Gyde Consulting

17 March 2022

RE: SECTION 4.55(1A) MODIFICATION APPLICATION TO SSD 10224 IN RELATION TO THE NEW PRIMARY SCHOOL AT EDMONDSON PARK, BUCHAN AVE, EDMONDSON PARK

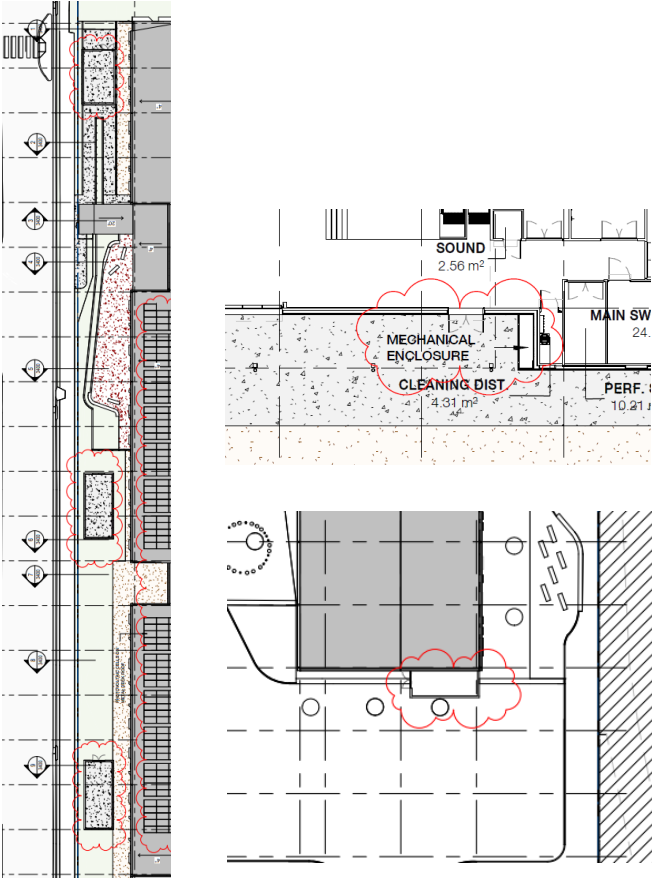
- Relocating the approved solar panels from the roof of Block B (Hall and COLA building) to the roof of Block A. An additional 20kW of photovoltaic panels are also proposed to be added to the system resulting in an overall capacity of 90kW.
- The addition of three mechanical enclosures along the Faulkner Way frontage. The enclosures will accommodate condenser units for the air-conditioning system. The walls of the enclosures are to be constructed of sound attenuating material and each will have a gate for access. The enclosures observe a setback of 1050mm from the boundary to allow landscaping to be provided between them and the street.

- Northern enclosure: 9.1m (L) x 5.3m (W) X 1.8m (H) – note the floor level of this enclosure sits 0.9m below the footpath level
- Central enclosure: 11.3m (L) x 4.9m (W) x 1.8m (H)
- Southern enclosure: 11.6m (L) x 4.9m (W) x 1.8m (H).
- Modification of the landscape design along the Faulkner Way frontage to accommodate the proposed mechanical enclosures. Importantly, the total number of trees along the frontage is retained.
- The addition of a mechanical enclosure on the southern end of Block B.
- The addition of a small mechanical enclosure adjacent to the hall/out of school hours care on the south-eastern elevation of Block B.
- The addition of a roof access hatch to Block A to facilitate servicing of the PV array.

Figure 4: Height of Solar Panel within highlighted area. Height limit in green dash (Source: TKD architects)

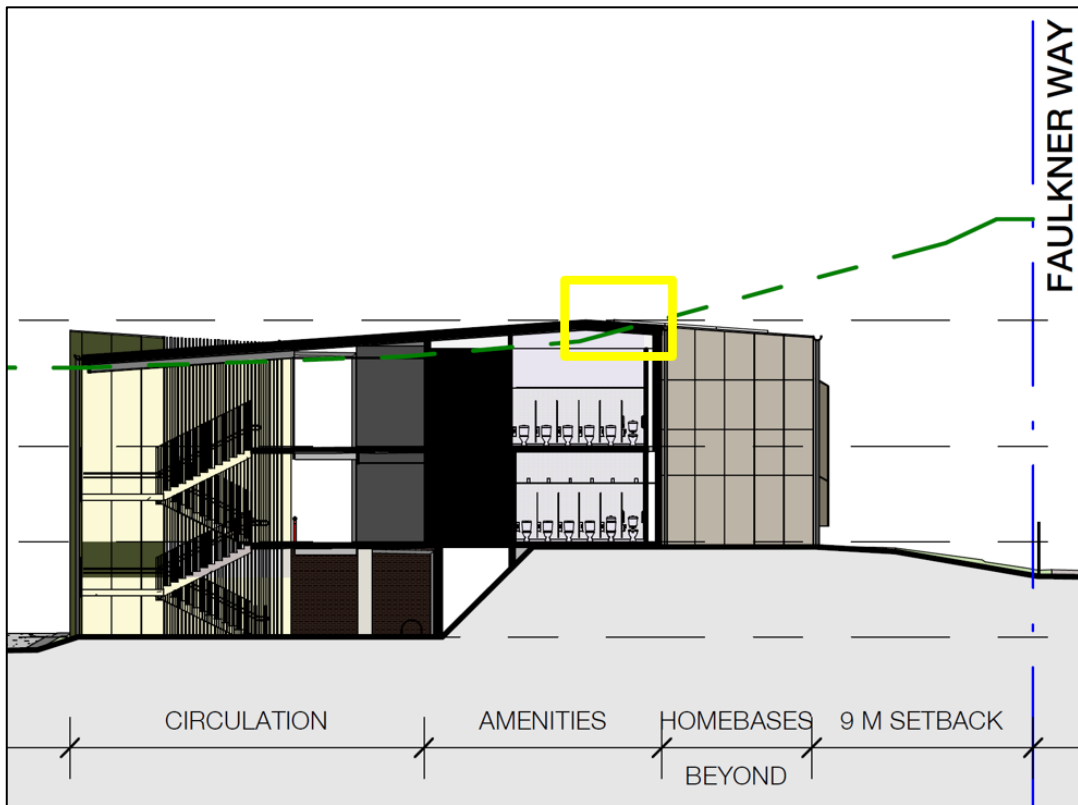
Since there are no substantive changes, the modified proposal remains generally consistent with the planning controls as detailed in the original application and as subsequently assessed by Minister for Planning and Public Spaces in granting the consent. The proposed solar panels will result in a minor increase in the building height, which will increase the extent of the breach of the height of buildings control.

Clause 18 - Height of Buildings (Appendix 1) of the Precincts – Western Parkland City SEPP applies a 15m height control to the site. Building A as approved exceeds the height limit by between 0.5 - 1.6m along the ridge of the roof. The addition of the solar panels on the western side of the roof will result in a minor increase in the extent of the breach. It is important to note that the breach is limited to a small section along the eastern edge of the panels, closest to the ridgeline, as is shown in Figures 4 and 5 below.

Pursuant to Clause 3.43 of the TISEPP, "development consent may be granted for development for the purpose of a school that is SSDA even though the development would contravene a development standard imposed by this or any other EPI under which the consent is granted." Notwithstanding, the proposed contravention to the height standard is reasonable for the following reasons:

- the proposed change does not alter the scale of the building or its height relationship to adjoining residential development
- there is no change in overshadowing
- the solar panels will be largely imperceptible from the public domain.

The proposed minor variation to the height control is therefore justified.
